Author: dttus Subject: Polygon Date: 12/28/2012 11:38:29 AM  
Plans are not complete, in that a full set of structural plans are not provided to facilitate a timely review and approval.

VOLUME 2 OF 2 - ZONING

# Summary of Comments on P:\Projects\1216-00\BIM\Revit\Families\TITLEBLOCKS\EXTELL Proposal\_atwalj.pdf

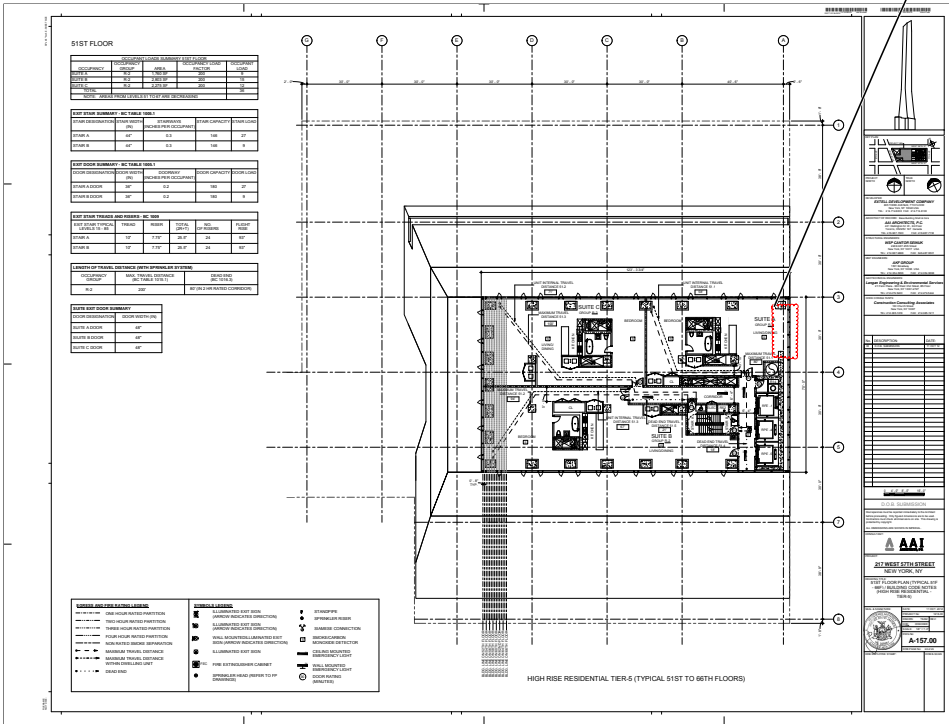
note required on elevation dwg. to indicate  
1 hr rated wall.

Propose mechanical room is not permitted to open into stair enclosure as per BC1019.1.2

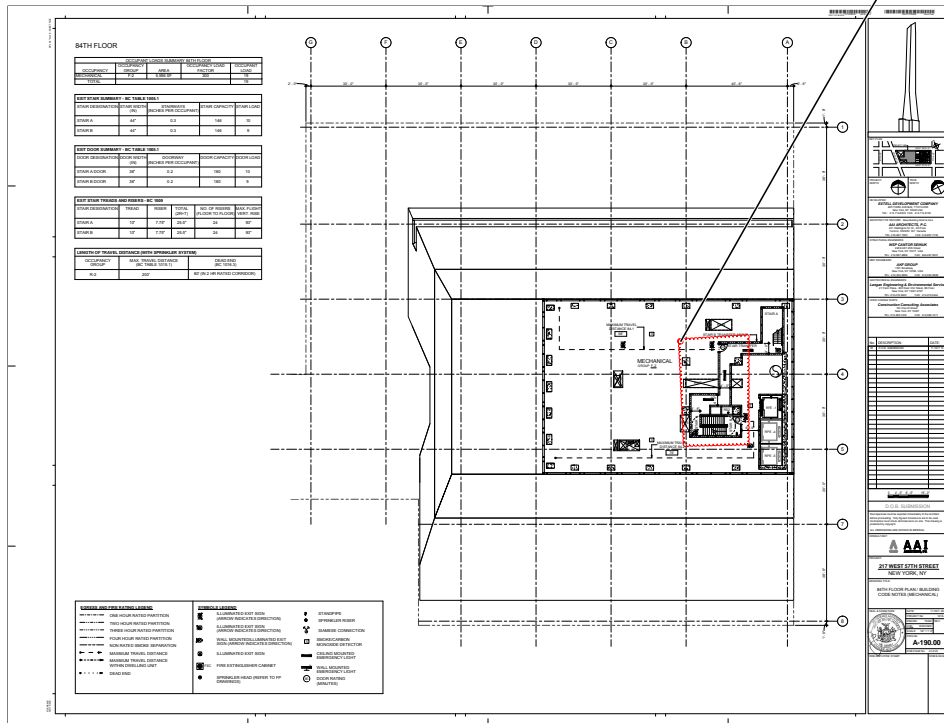
BC 403.11.1 Emergency power systems for assembly occupancy

1. Exit signs and means of egress illumination required by chapter 10.2.
3. emergency voice communications systems; and
4. Electrically powered fire pumps, unless electrical power to the motor is taken ahead of the main from the street side of the service switch.

Author: dtitus Subject: Polygon Date: 1/2/2013 11:59:00 AM  
All interior stairs must lead to the roof as per BC 1009.12

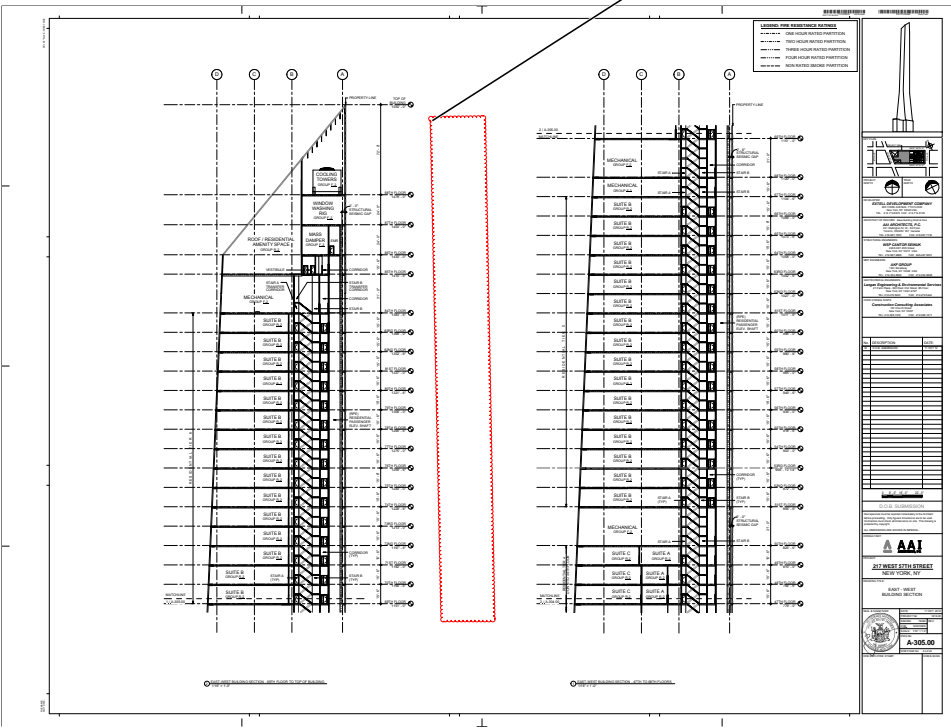
Provide all schedules windows, doors (indicate FPSC on all fire rated doors) etc.

Provide structural peer review report as per BC 1627.

Summary of Comments on FP-401.00

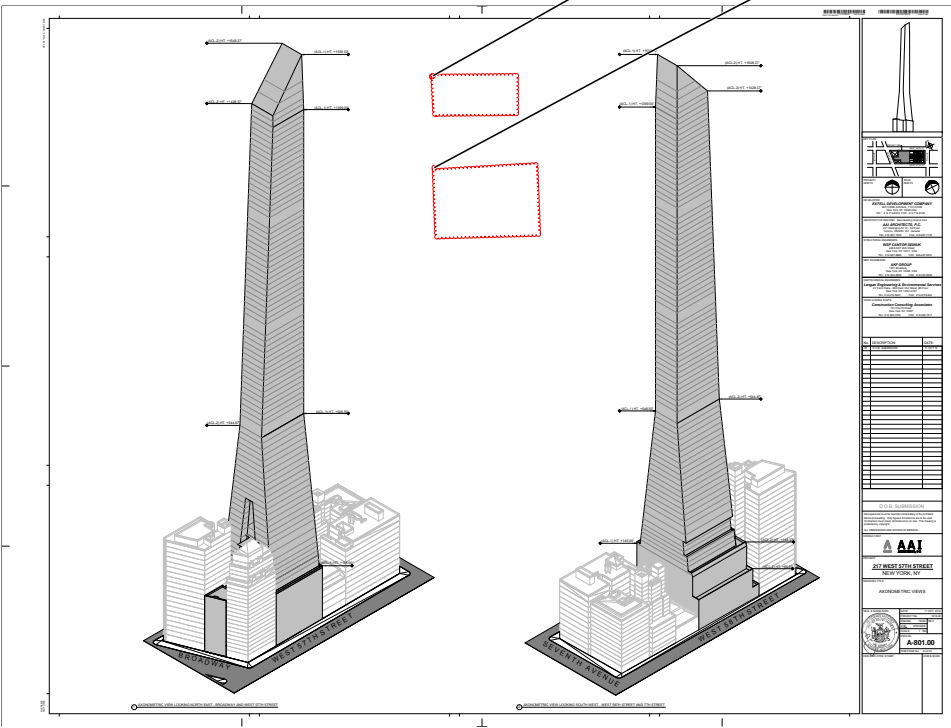
Provide building elements, exterior walls of non-combustible construction with fire-resistance ratings for Type I-B construction (BC 602.1, BC 602.2).

Author: dtitus Subject: Polygon Date: 1/8/2013 9:12:55 AM  
Please provide a complete water and gas riser diagram.
